**JUNE 28, 2007 MEETING MINUTES AND PROGRESS REPORT
UGI COLUMBIA GAS PLANT SUPERFUND SITE
COLUMBIA, PENNSYLVANIA**

DATE: July 2, 2007
TO: Jim Vagra
FROM: Ross P. Ulmer *RPU*
Todd D. Trotman *TD*
SUBJECT: UGI Columbia Gas Plant Superfund Site
Site Grading
Additional Information and Clarifications

CONCRETE WALL
CAPPING PLAN
UGI COLUMBIA GAS PLANT SUPERFUND SITE
COLUMBIA BOROUGH, LANCASTER COUNTY, PA

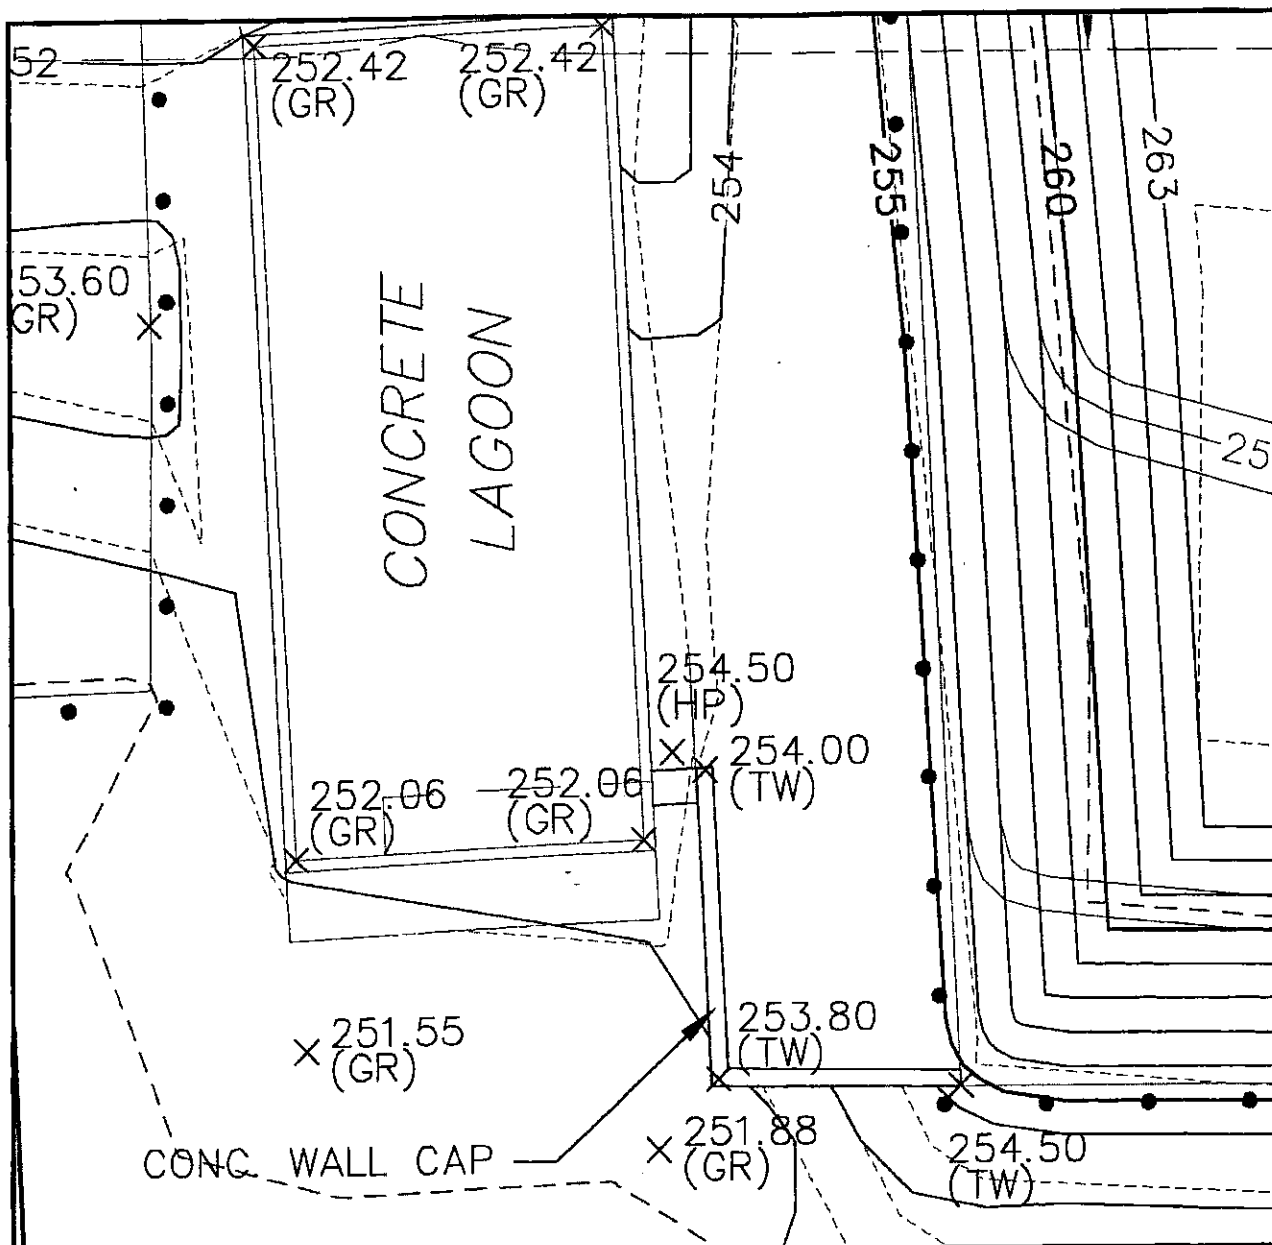
Concrete Lagoon

Additional grading and construction details for this area are shown on the attached sheet.

1. EXCAVATE BEHIND THE EXISTING WALL TO THE LIMITS REQUIRED FOR CONSTRUCTION OF THE CAP AND LIGHT DUTY PAVEMENT.
2. CLEAN TOP OF EXISTING WALL AND INSTALL DOWELS AND/OR STRAIGHTEN AND REUSE EXISTING REBAR. DOWELS OR REBAR SHALL BE SPACED APPROXIMATELY 3 FEET ON CENTER; 3 INCH TOP/4 INCH BOTTOM TYPICAL EMBEDMENT. EPOXY IN PLACE.
3. FORM AND POUR CONCRETE CAP. CONCRETE SHALL BE PENNDOT CLASS A CONCRETE, 3000 PSI.
4. REMOVE FORMS AND PROVIDE BROOM FINISH ON ALL EXPOSED SURFACES.
